CW BLDR-2023-32086 OSWP 2023

ICHD - ENVIRONMENTAL HEALTH DIVISION

SEPTIC: IMPROVEMENT PERMIT / AUTHORIZATION TO CONSTRUCT / OPERATION PERMIT / EXISTING SYSTEM

PERMIT SNAPSHOT REPORT OSWP-2023-29368 FOR IREDELL COUNTY

INITIAL SITE SKETCH

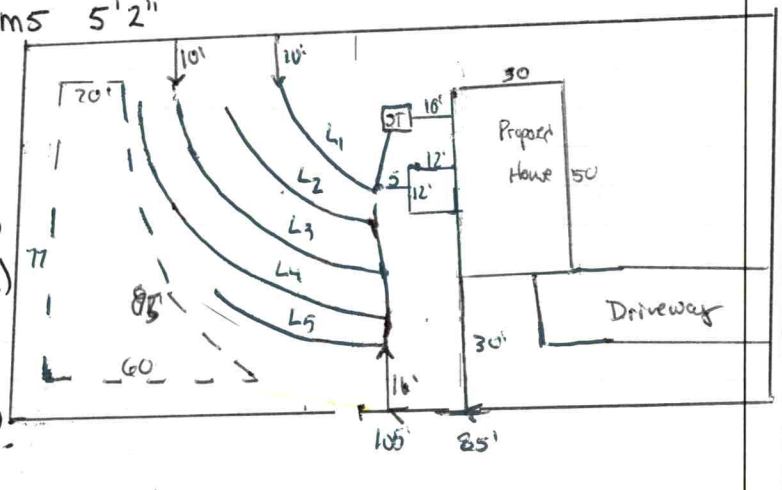
Comments / Conditions: Remove ridge at back of lot in repair area. DO NOT otherwise grade, bury utilines, etc in septic area. Divert all drainage toward front of house. Follow contour

When installing & utilize serial distribution. Bring plumbing out as shallow as possible to acheive fall to septic. See attached floorplans.

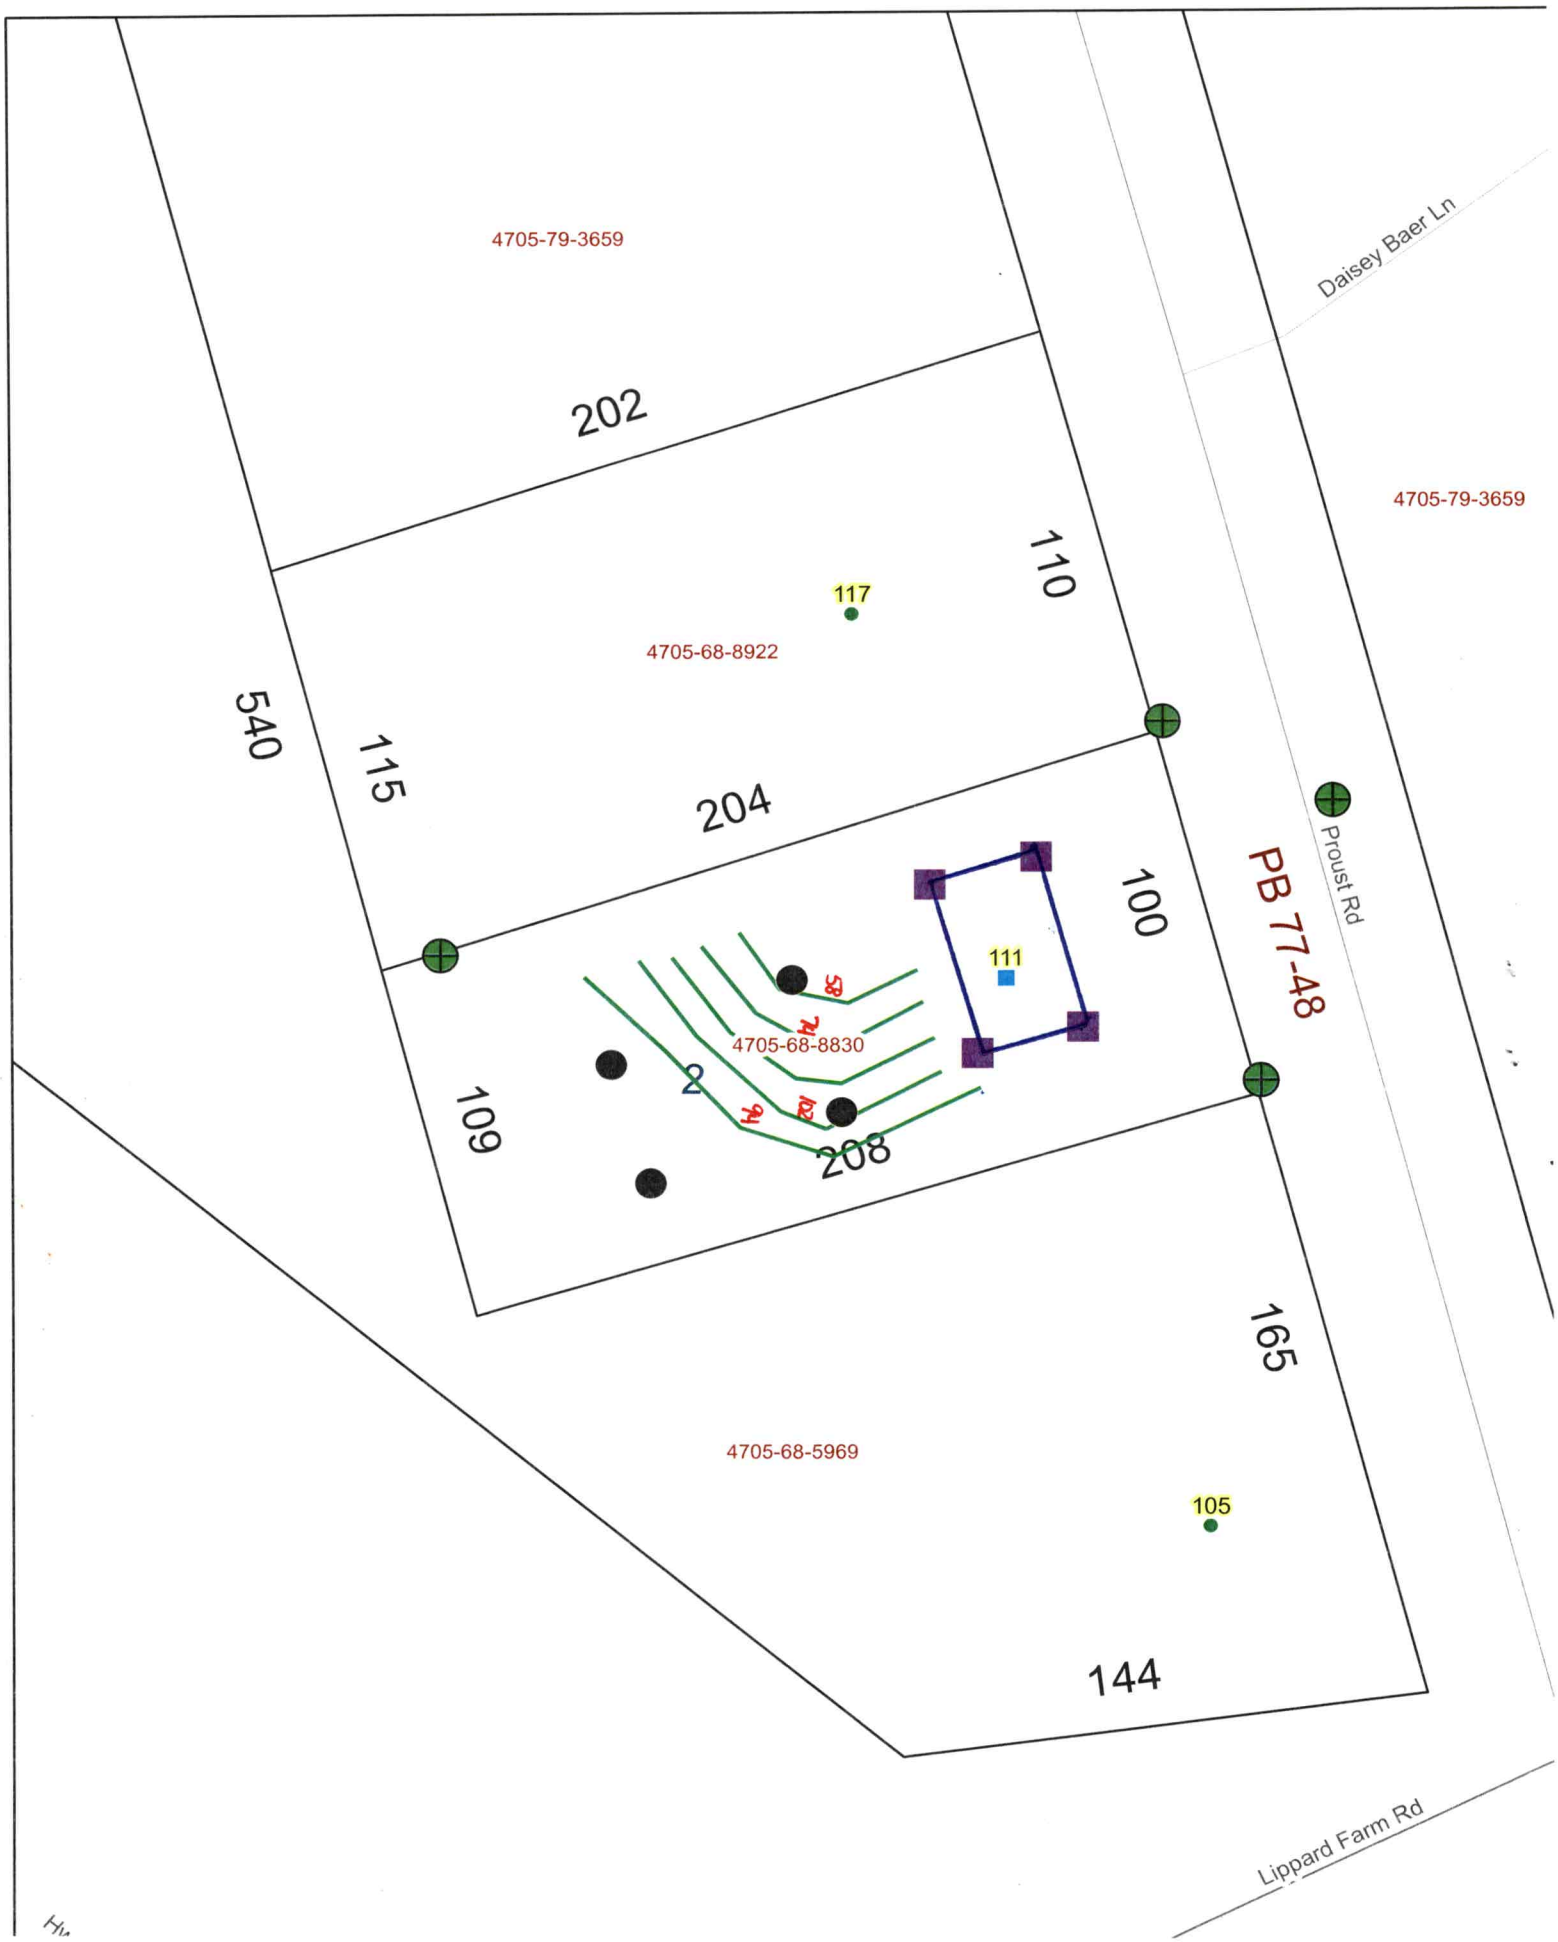
more than 4" of elevation
change
Shoot top drainline
be @ least 22" above that
